TECHNICAL BULLETIN

[Issue No.] GOT-A-0052

[Title] Change of the D-sub connector of the RS-422 Conversion Unit (GT15-RS2T4-9P)

[Relevant Models] GOT1000 Series GT15-RS2T4-9P

■ Rating plate (GOT rear face)

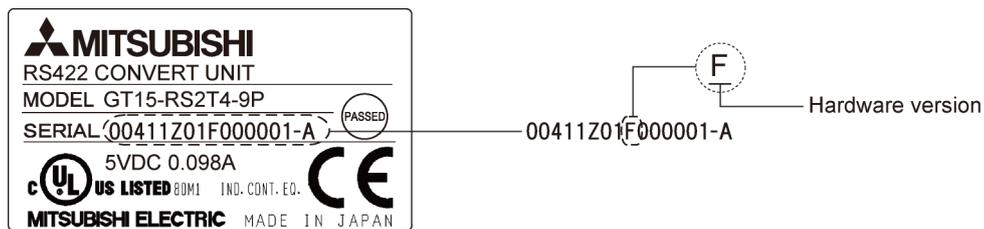
The following shows how to check the hardware version.
